3.1 LAND USE, ZONING, PUBLIC POLICY AND COMMUNITY CHARACTER COMMENTS AND RESPONSES

Land Use, Zoning, Public Policy and Community Character

August 10, 2009

Figure 3.1-1: Entry Sign Elements A
U.S. Route 6, Town of Southeast
Putnam County, New York
Source: DCAK-MSA Architecture, 06/24/09
Scale: As shown

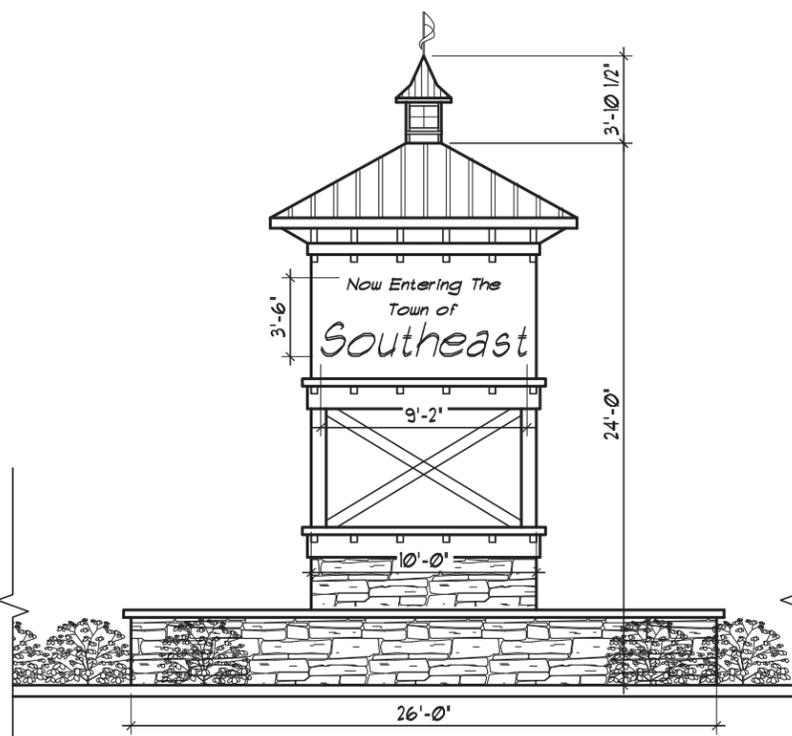
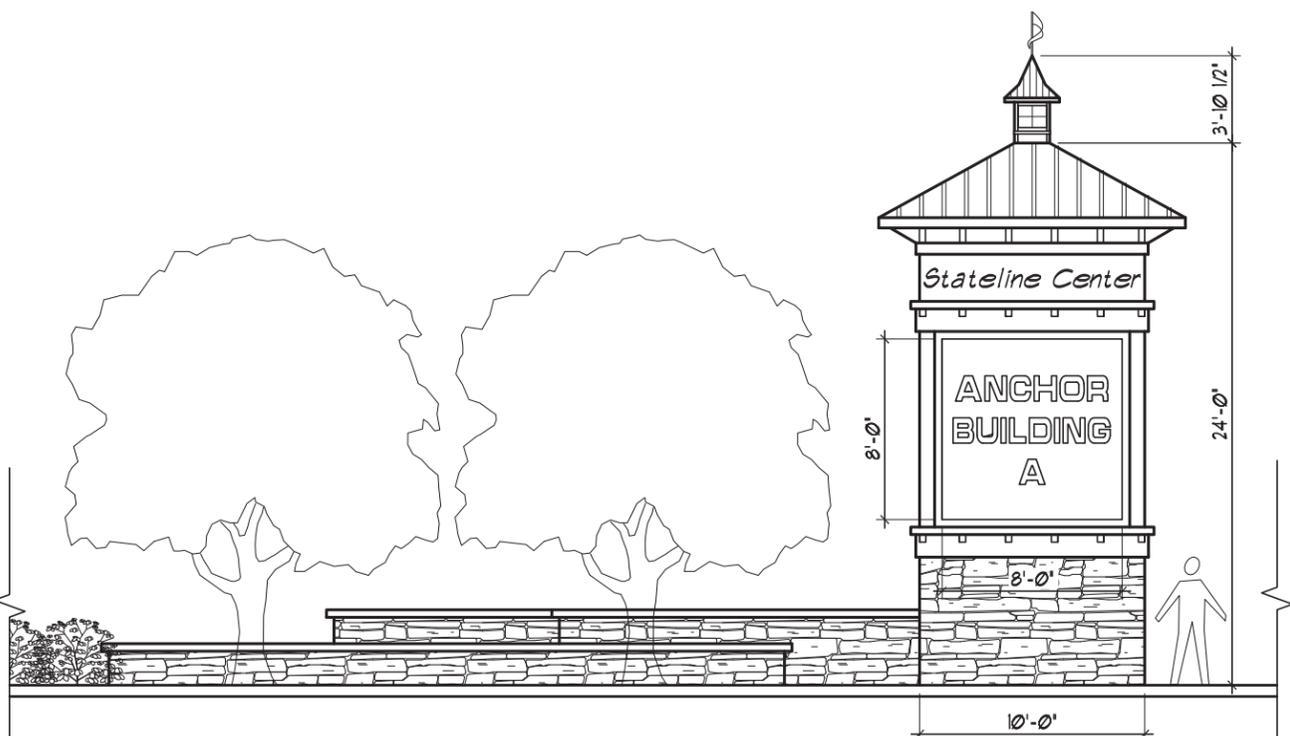
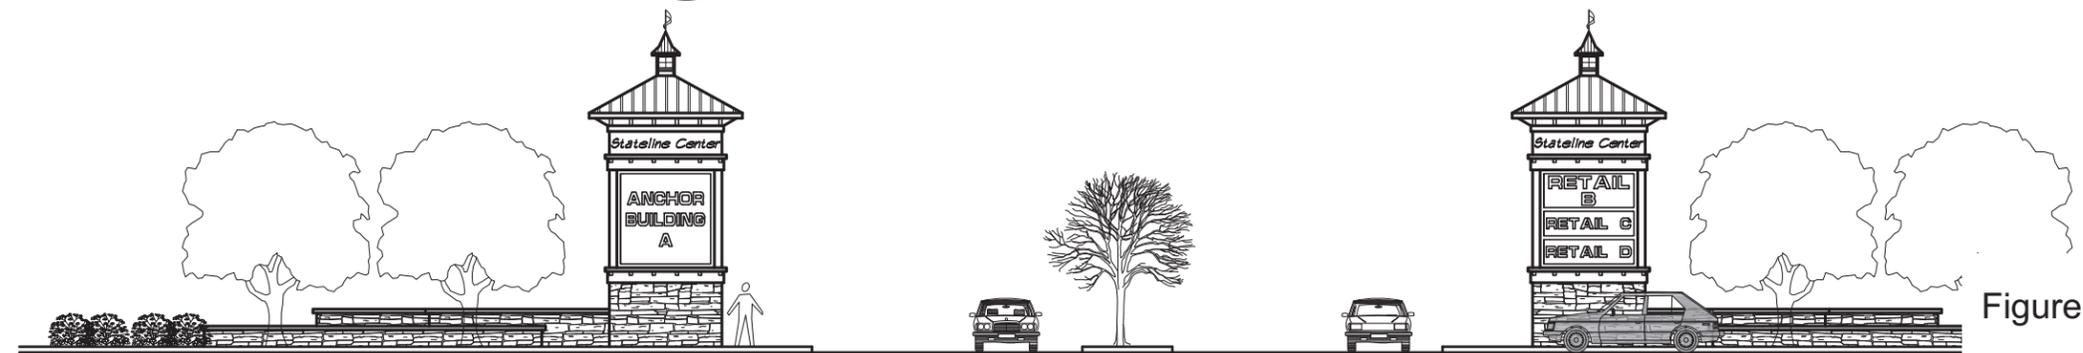
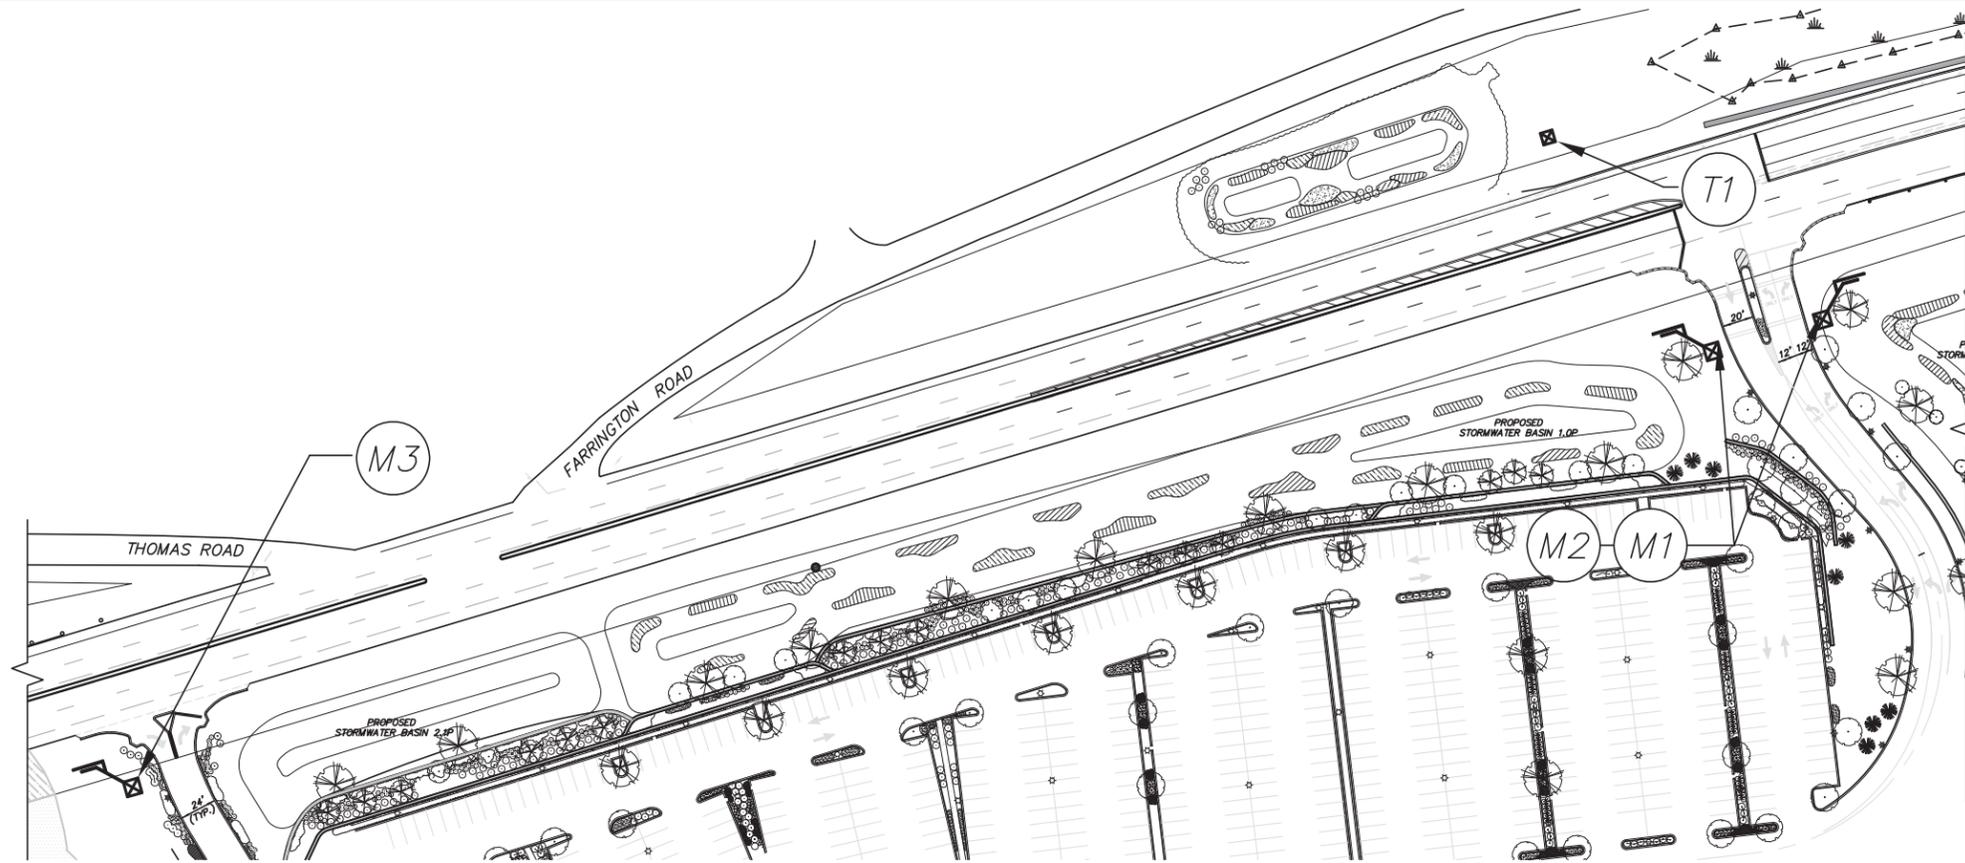
Comment 3.1-1 (Ms. Lynn Eckhart, Public Hearing, July 14, 2008): I assume the signage will conform with the new codes because it looks to me like some of the signage shown would not.

***Response 3.1-1:** Entrance signs are proposed at each of the three vehicular access points (two for retail and one for office) to the project site. In addition, a "Now Entering the Town of Southeast" sign element is proposed for a location roughly across US Route 6 from the main project entrance. A variance for the size and number of signs will be sought once the tenants are determined and the designs finalized during the final site plan approval process. Details on the retail center signage program, including sign descriptions and locations, can be found on FEIS Figures I-5 (Overall Site Plan), 2-2 (I-84 Sign Element View), 3.1-1 (Retail Center Entry Sign Elements A) and 3.1-2 (Retail Center Entry Sign Elements B). The Applicant will continue to refine the signage plan, with input from the Town, through the environmental review and site plan processes.*
